Paper No. CB(2)995/99-00(02)

**LEGISLATIVE COUNCIL SUBCOMMITTEE TO FOLLOW UP
ON THE OUTSTANDING CAPITAL WORKS PROJECTS OF
THE TWO PROVISIONAL MUNICIPAL COUNCILS FOR
INCLUSION INTO THE GOVERNMENT'S
PUBLIC WORKS PROGRAMME**

370RO – Hammer Hill Road District Park

**303CR - Hammer Hill Road District Park
(Layout Plan and Cost Estimate)**

Appendix II
(Option A)

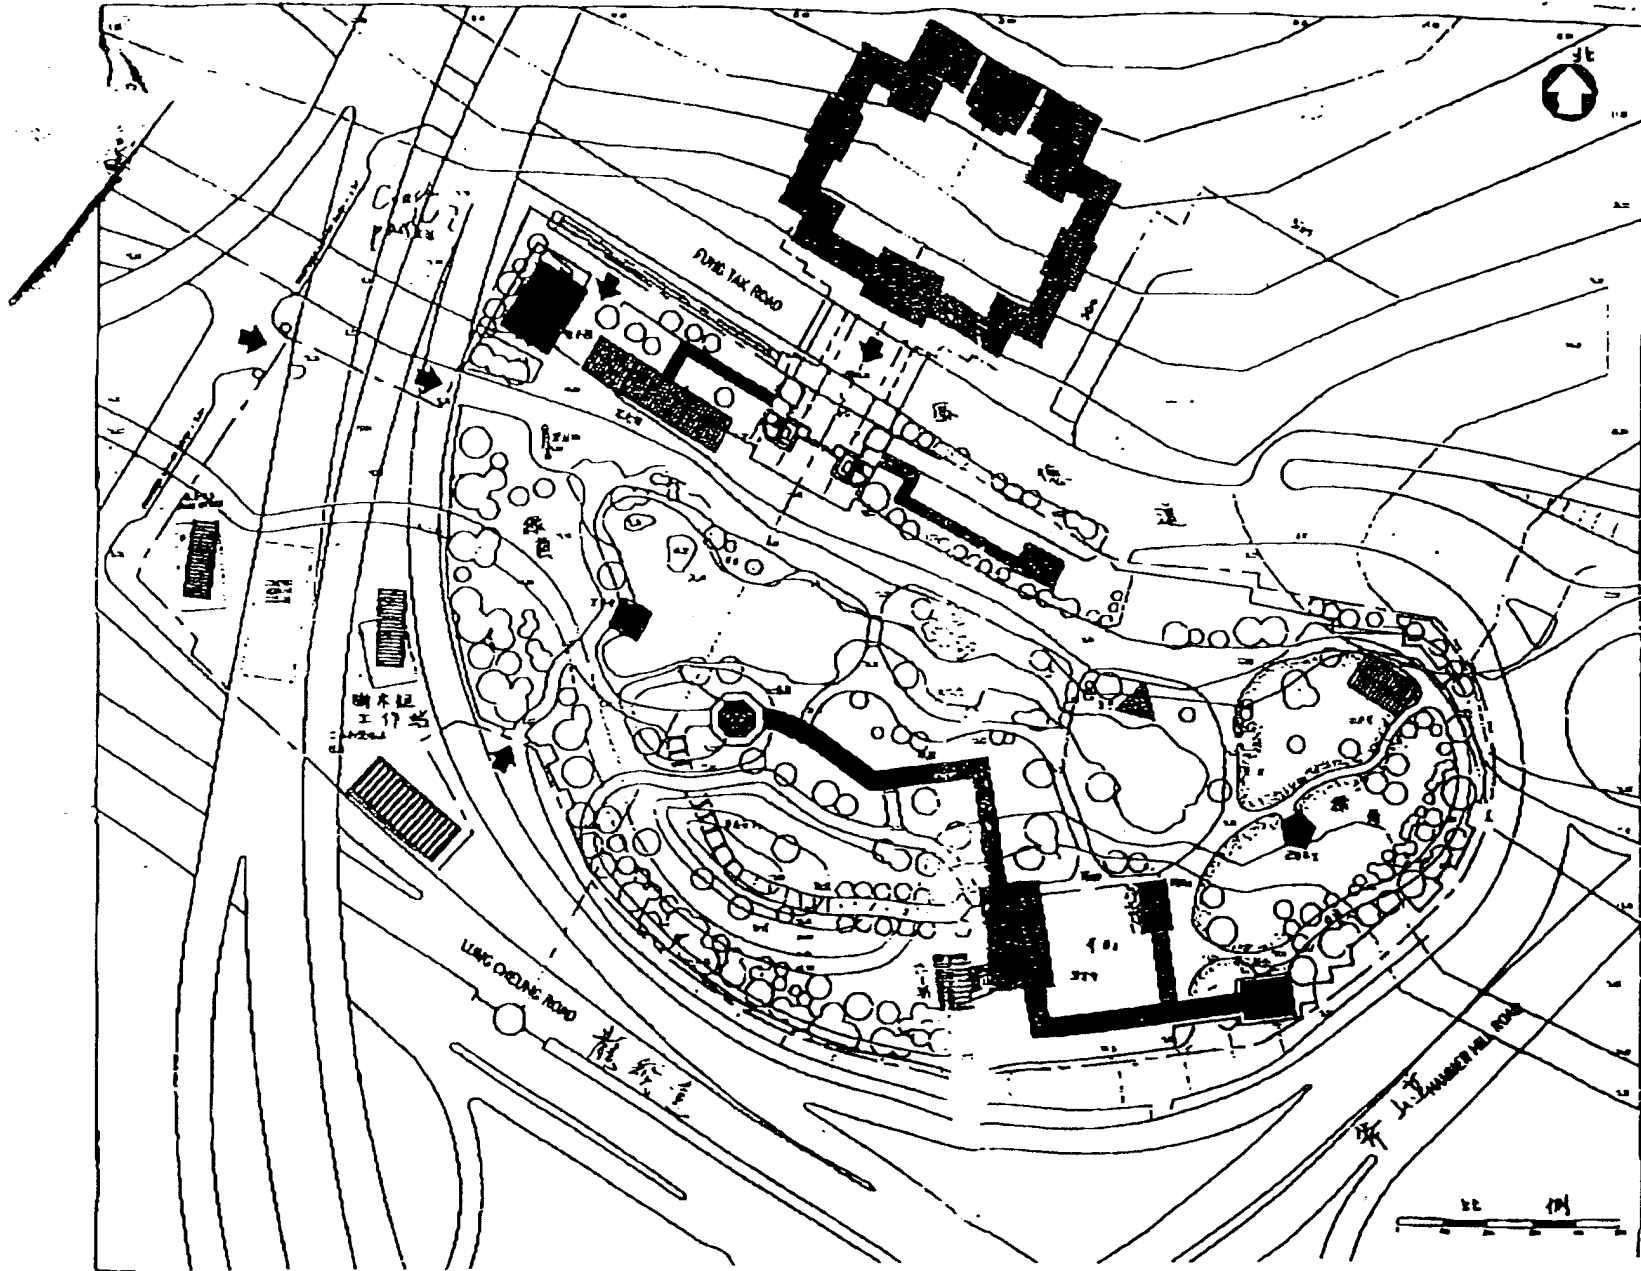
- a) This is a design based on the approved conceptual layout featuring -
 - (i) a traditional Chinese garden in the style of the Tang Dynasty;
 - (ii) adequate access points will be strategically positioned for visitors from the MTR exit at Hollywood Plaza, the proposed coach park and residential areas at Fung Tak Road and Hammer Hill Road. The main entrance will be located at Fung Tak Road with access to the landscaped deck linking to the Local Open Space development on the opposite side of the road;

- (iii) six scenic zones guided by the themes on the culture, history and arts of the Tang Dynasty. Five Chinese pavilions of unique themes with historic reference to poets and emperors of the Tang Dynasty and stone engraving of Tang poems will be provided throughout the park as the focal point of interests. Each scenic zone will be highlighted by planters with special characteristics on their fragrance, colour, leaves and stems;

- (iv) a small hill of about eight meters above the nearby covered walkway with footsteps leading to the hilltop will be provided in the south overlooking a long and irregular shape pond stretching in the middle of the park. The pond will be divided into three levels by natural rocks with blended streams;

- (v) two lawn areas will be provided in the eastern side;
- (vi) two covered walkways with stone engraving of Chinese calligraphy embedded on the wall will be provided. One will be located in the north linking up the exhibition hall at the north west corner to the main entrance fronting Fung Tak Road. Another one will be provided in the centre linking up two pavilions, a senior citizens hall for playing Tai Chi, a kiosk and a public toilet in the south;

- (vii) the outskirts of the park will be lined up with trees and bushes and a white wall in the Tang Dynasty style;
- (viii) the north west boundary along Fung Tak Road will be set back by six meters from the original boundary to allow a buffer area to facilitate circulation of visitors from the MTR exit to Chi Lin Nunnery;

- (ix) adequate disabled access connections will be provided. The small hill in the south is the only spot where the disabled cannot reach by wheelchair. The purpose of providing the hill is to screen off the heavy traffic noise generated from the busy Lung Cheung Road; and

- (x) the tree depot and the ancillary facilities of the park including the management office, store room, staff room, waste collection chamber will be located underneath the flyover. Similarly, the structures will be built in the traditional Chinese style in order to blend in with the overall architectural style of the park.

This design covers all the features in the approved schedule of accommodation and conceptual layout with quality art works and decorations signifying the culture of Tang Dynasty. There is a bountiful supply of shelters in the form of pavilions and covered walkways. From the design point of view, the pavilions and covered walkways are essential in creating different focal points of interest. They also act as natural space dividers for different planting design.

There are many structures and the cost is relatively high. It is the most expensive option (\$205.28 million inclusive of 16% on-cost in MOD price).

Appendix III
(Option B)

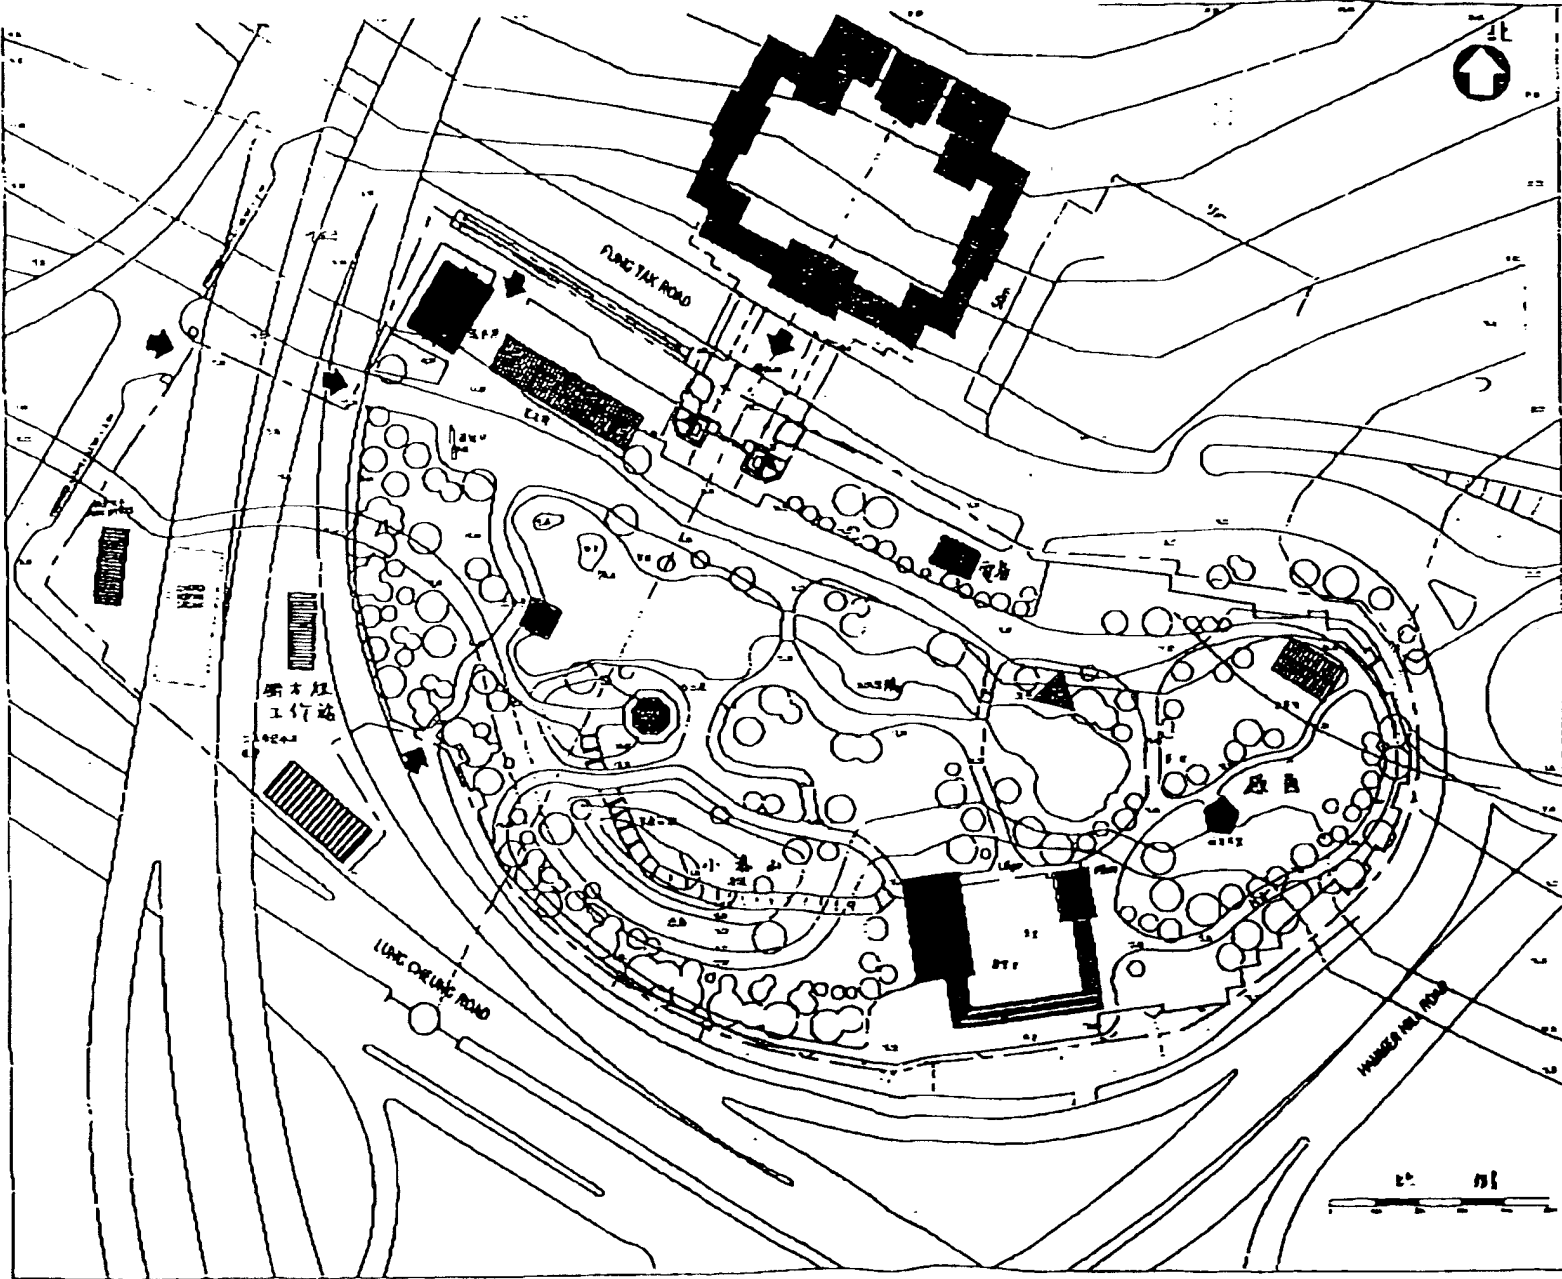
- e) The design is similar to Option A, with a reduction in decorations and the deletion of the following structures in order to trim down the cost -
- (i) the covered walkway to the exhibition hall and transformer room;
 - (ii) one pavilion (the Painter's Pavilion);
 - (iii) the covered walkway between the Senior Citizens Hall and Shan Chi Chamber; and
 - (iv) a small toilet in the south.

It retains the major features in the approved conceptual layout. As compared with Option A, there are fewer structures and more soft landscaping. The number of pavilions and covered walkways are reduced but is considered adequate for providing rain-shelters to the public. There is relatively more open space. The cost is \$177.57 million in MOD price and is lower than Option A by \$27.71 million.

There is a reduction in decorations and art works. With the deletion of some covered walkways, some stone carvings will be exposed in the open air and will be subject to weathering. Besides, toilet facilities are less than those in Option A.

Appendix IV
(Option C)

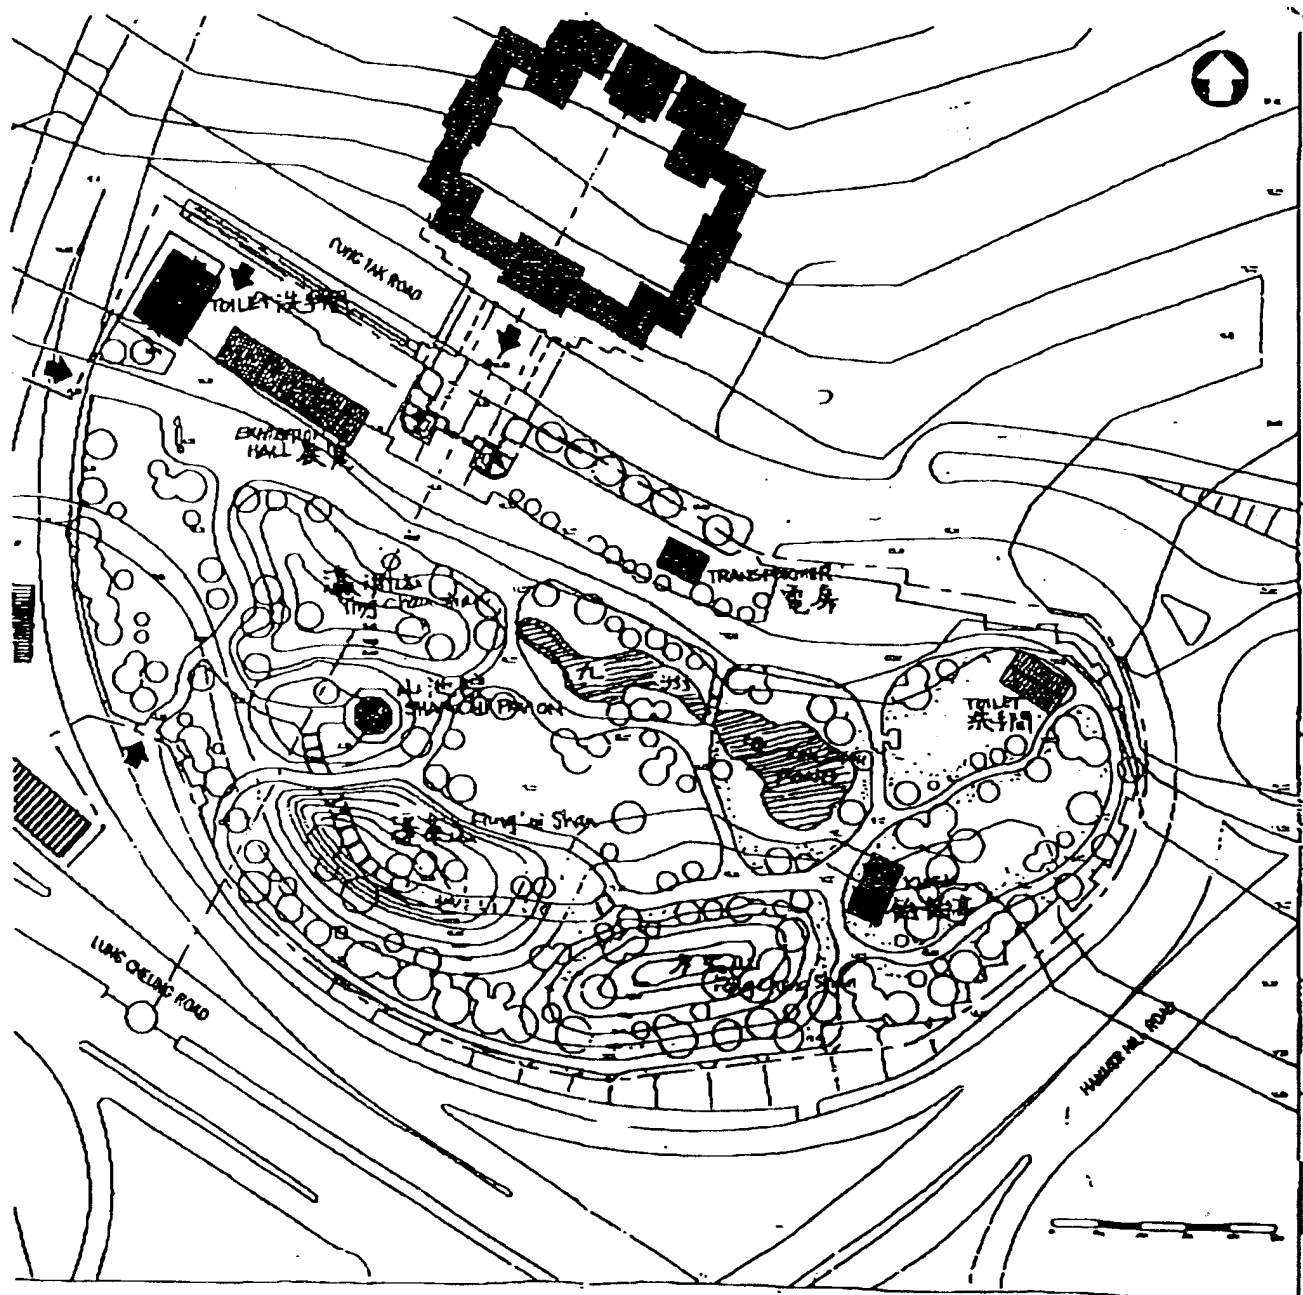
- g) This is the design with the lowest estimated cost i.e. \$133.96m (MOD price). There is a further reduction in the number of structures as compared to Option A. They include -
- (i) all the covered walkways;
 - (ii) the Senior Citizens Hall;
 - (iii) four pavilions (Calligrapher's Pavilion, Poet's Pavilion, Zhen Han Pavilion and Painter's Pavilion);
 - (iv) the Tang Gong platform;
 - (v) islands;

- (vi) a pond and a bridge; and
- (vii) a small toilet in the south.
- h) The reduction in structures will be replaced by the addition of artificial hills and planting areas. This simple design deviates significantly from the approved conceptual layout. Apart from the kiosk, there will be only one pavilion providing shelter to the public.
- i) The pros and cons of this design are -

This is the least costly design with the most soft landscaping area and open space. The estimated cost is \$133.96m (MOD price). It is lower than Option A by \$71.32m and Option B by \$43.61m (MOD price). This design places heavy emphasis on the imitation of nature with rocks, water, planting, etc. It creates a very serene surrounding.

This is a total different approach. According to the project architect, the three artificial hills and the pond may give an impression to some visitors that the park is a Buddhist garden. Besides, there is only one pavilion in the park which is considered insufficient in providing shelters to the public. Toilet facilities are also less than those in Option A.

9. Of the three options set out in para. 5 above, CLN favoured Option C.

A preliminary conceptual plan is at Annex 2.

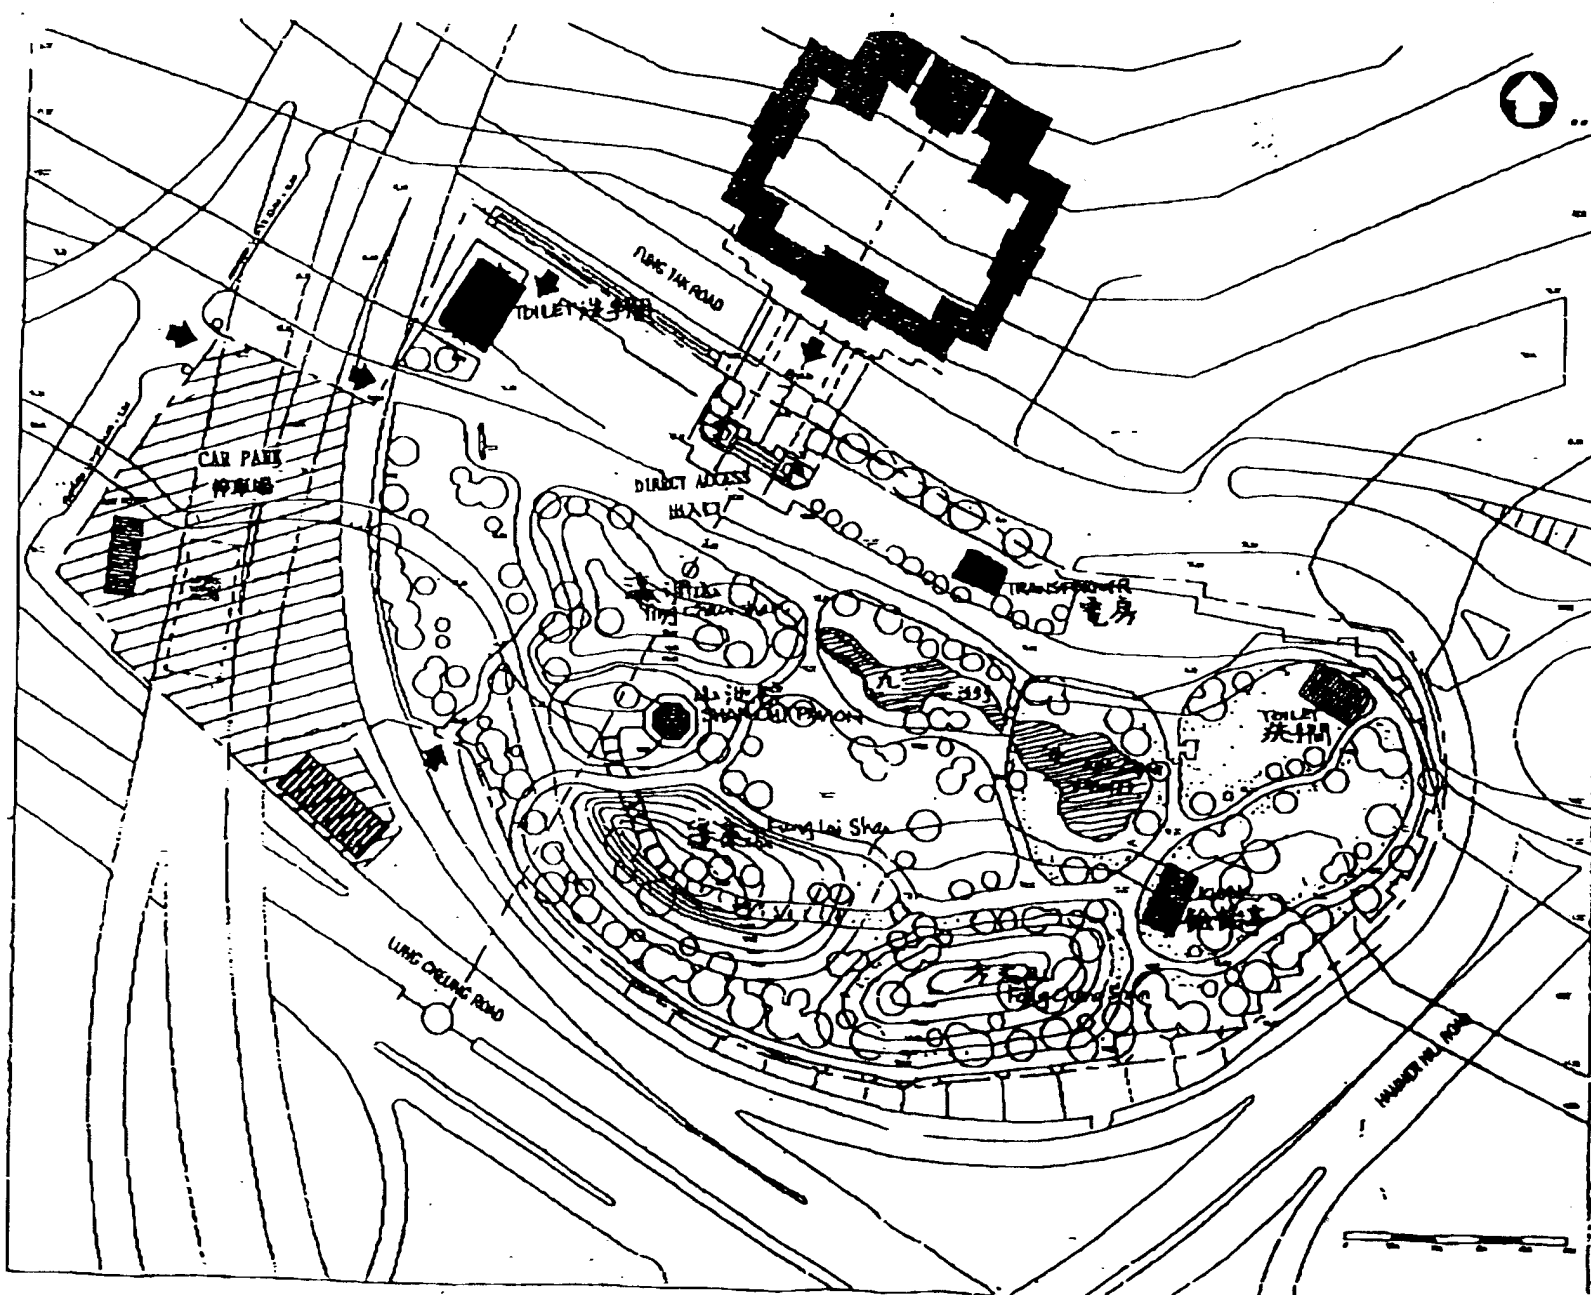
4. At a recent meeting with the Chi Lin Nunnery Management, Chi Lin indicated their preference for a park with a theme stressing on imitation of nature. In their view, the district park should be a rest garden with minimum hard structures and more soft-landscaping features. Tall trees should be planted on hilly ground on the southern boundary of the site as a natural shield to screen off traffic on the flyovers. Ample car-parking spaces should be provided for visitors. As there is already a properly fabricated exhibition hall in the Complex premises which will be opened to the public, they considered the provision of a separate exhibition centre in the park a duplication.

- to reduce the hard-structure element by deleting the covered walkways, exhibition hall, senior citizens' hall, tree depot and some pavillions;
- to provide a visitors' carpark at the western end of the park; and
- to provide a direct access from the park to the Chi Lin Nunnery Complex.
